Austin Energy  
Building Service Planning Application (BSPA)

1710 E. 18th 78702

1710 E 18TH ST  
NEW CONSTRUCTION  
TWO-FAMILY PROJECT  
JEFF GRIER  
1710 E 18TH ST  
AUSTIN TEXAS 78702  
PHONE: 512-242-7752  
EMAIL: ROBERT@EASTSIDE.COM

SITE PLAN

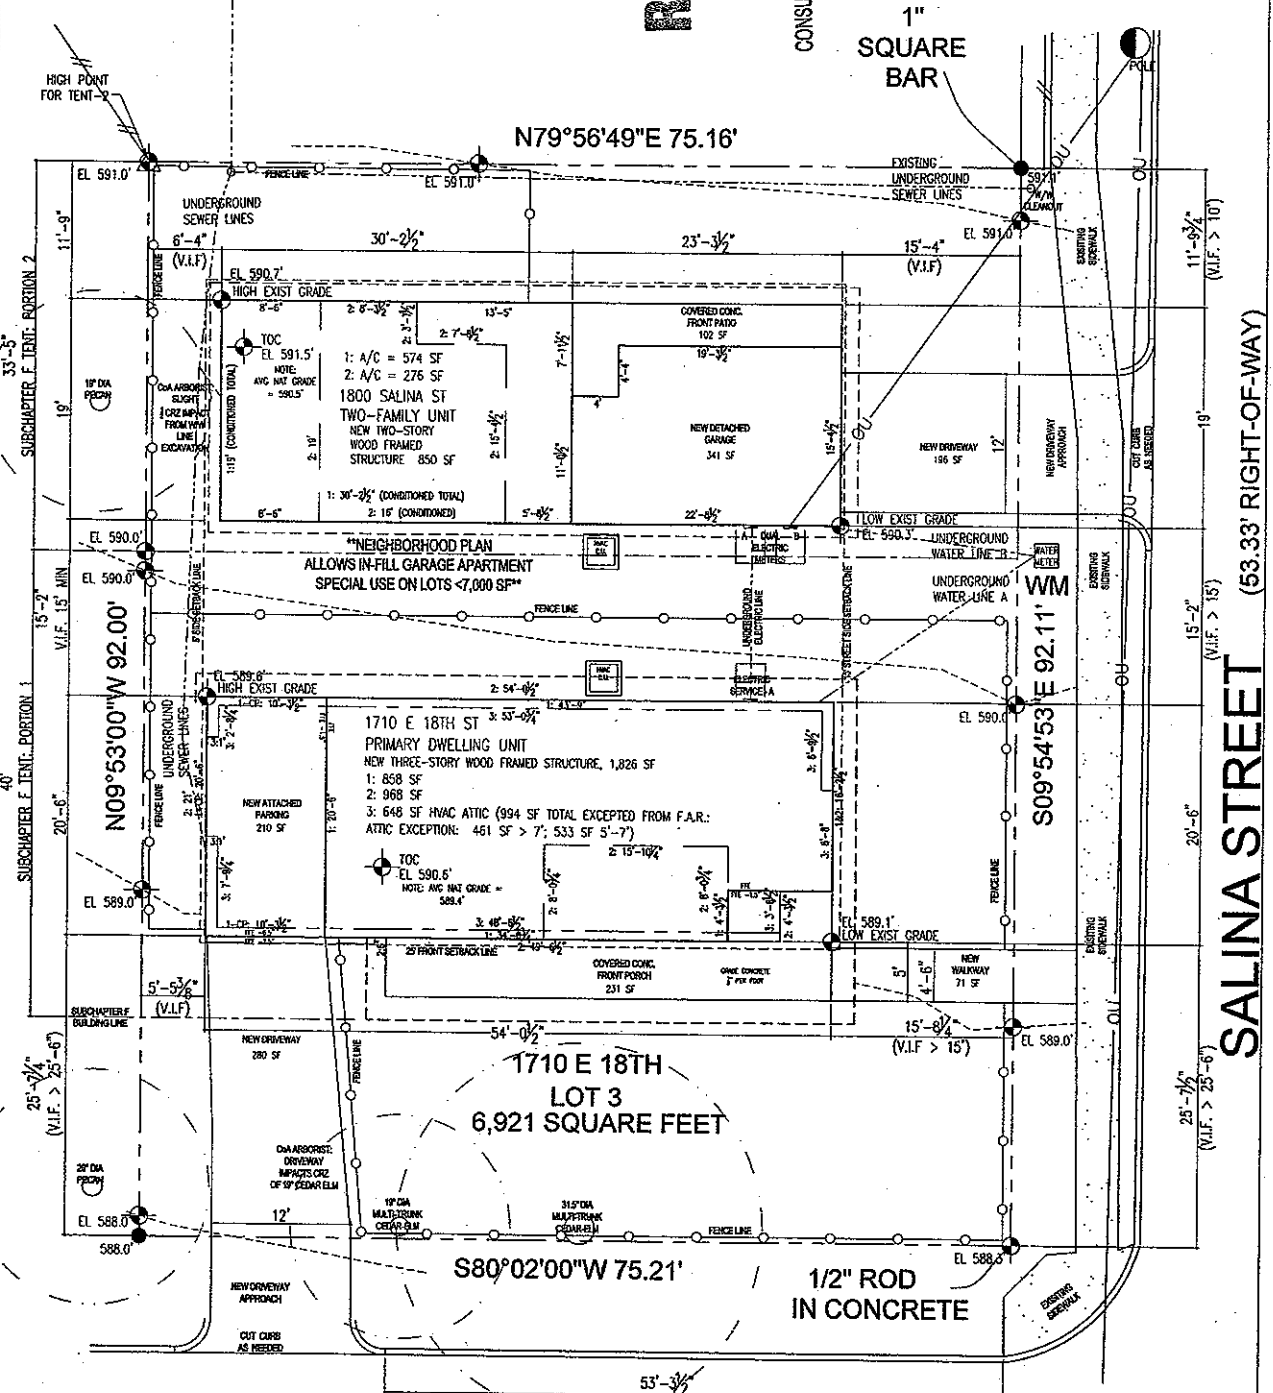
\*COA Records show meter will be in driveway  
Move meter to driveway

**A-4**

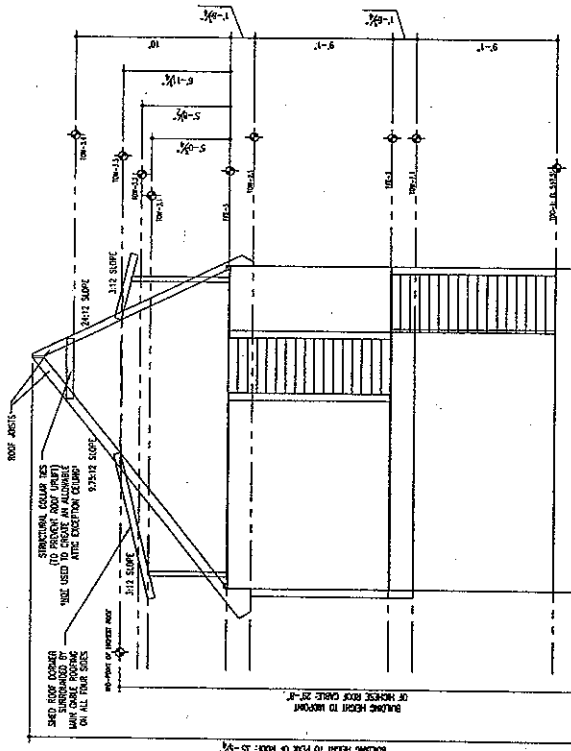
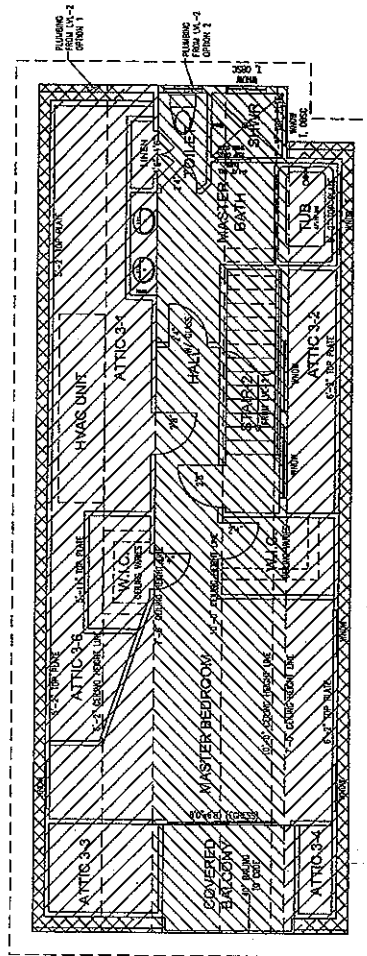
"A": ATTIC CEILING LESS THAN 5', 93 SQ FT

<sup>M</sup>B<sup>N</sup>: ATTIC CEILING 5'>7', 533 SQ FT

"B"@ 533 SF > "C"@ 461 SF - - ATTIC EXCEPTION ALLOWED

"C": ATTIC CEILING >= 7', 461 SQ FT
